**SUBJECT:** FUSELAGE - INSPECTION OF THE SHOULDER HARNESS ATTACH BRACKET

**SYNOPSIS OF CHANGE:**

Extended the EFFECTIVITY, changed the shoulder harness attach bracket part number and rewrote the ACCOMPLISHMENT INSTRUCTIONS.

**Service Instructions No. 1173, Rev. I**

Figure 1

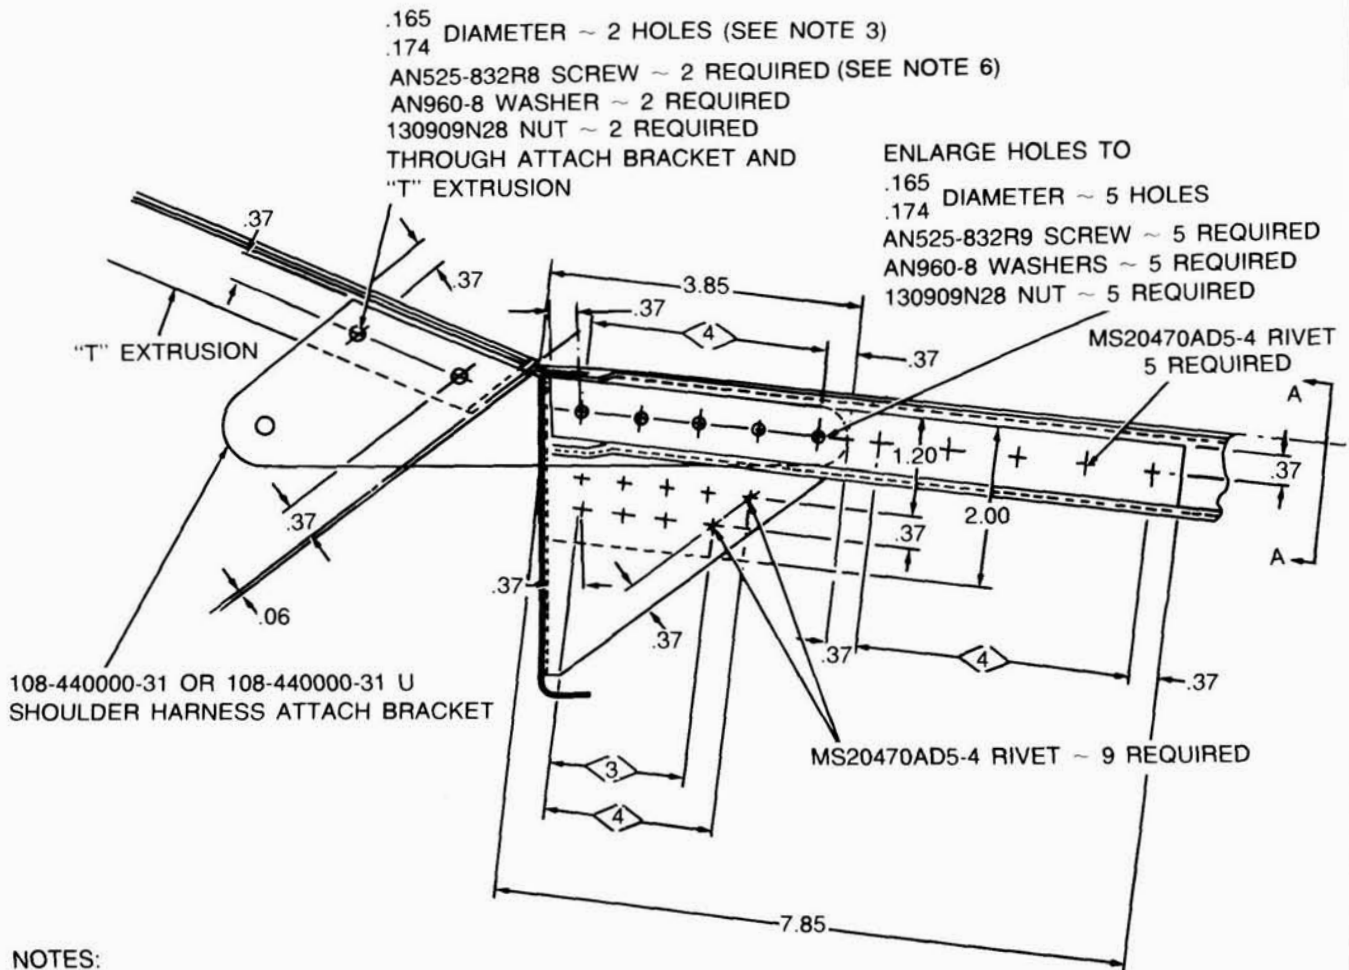
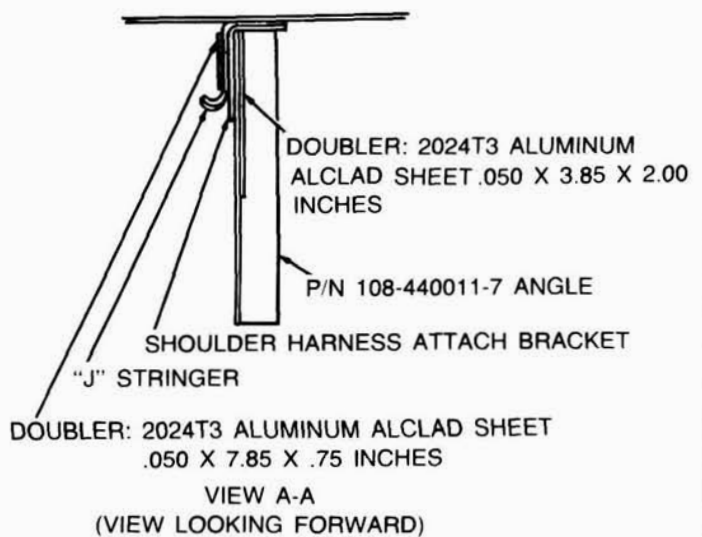
4. Drill out the five rivets aft of the baggage compartment bulkhead attaching the P/N 108-440000-31 shoulder harness attach bracket to the "J" stringer and the P/N 108-440011-7 angle (see Figure 1). If three rivets are installed through the bracket and the "T" extrusion forward of the bulkhead, drill these out also.

5. Remove the P/N 108-440000-31 shoulder harness attach bracket and inspect for proper edge distance as shown in the illustrations. Also inspect for elongated and/or double drilled holes in the bracket, "J" stringer and angle aft of the bulkhead. If proper edge distances exist on the P/N 108-440000-31 bracket and the holes are satisfactory, refer to Figure 1 for hole sizes and hardware for reinstallation of the bracket. Also refer to Notes 1, 2 and 3.

6. In the event elongated holes, double drilled holes or insufficient edge distances are encountered, refer to Figure 1 for fabrication of doublers, installation of the two doublers and installation of a new P/N 108-440000-31 U shoulder harness attach bracket. Refer to Notes 1 through 6 as they relate to various areas of the illustration.

1. SMOOTH ALL ROUGH EDGES AND REMOVE BURRS FROM ALL REWORKED AREAS. APPLY ZINC CHROMATE PRIMER TO ALL BARE METAL, INCLUDING HOLES, PRIOR TO ASSEMBLY.
2. ALL DIMENSIONS ARE IN INCHES
3. IF THREE RIVETS WERE ORIGINALLY INSTALLED IN THE SHOULDER HARNESS ATTACH BRACKET FORWARD OF THE BULKHEAD, USE THE FORE AND AFT HOLES FOR THE SCREWS
4. MAKE BOTH DOUBLERS (IF REQUIRED) FROM THE .050 x 2 x 12 2024T3 ALUMINUM ALCLAD SHEET SPECIFIED IN THE MATERIAL SECTION. TRIM THE FORWARD AND TOP EDGES OF BOTH DOUBLERS AS REQUIRED TO ASSURE PROPER FIT.
5.  $\diamond$  DENOTES APPROX. EQUAL SPACES (WITHIN  $\pm .06$ )  
 X DENOTES NO. OF SPACES
6. IF THE SHIM SPECIFIED IN STEP 8 IS REQUIRED, LONGER AN525-832R SCREWS MAY ALSO BE REQUIRED.

**Figure 2**  
**View - Looking Forward**

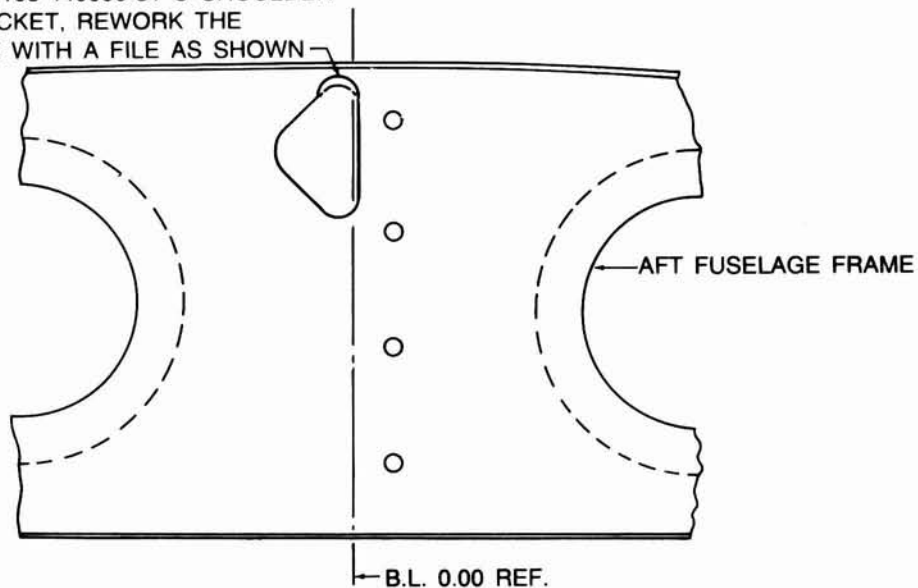
7. If necessary to obtain the proper edge distance on the new P/N 108-440000-31 U shoulder harness attach bracket, the triangle cutout in the aft fuselage frame may be reworked as shown in Figure 2. The cutout in the baggage compartment aft bulkhead may also be reworked if necessary.

IF NECESSARY TO OBTAIN THE PROPER EDGE DISTANCE ON THE P/N 108-440000-31 U SHOULDER HARNESS ATTACH BRACKET, REWORK THE CUTOUT IN THE FRAME WITH A FILE AS SHOWN

Care should be taken to avoid damaging the static air line.
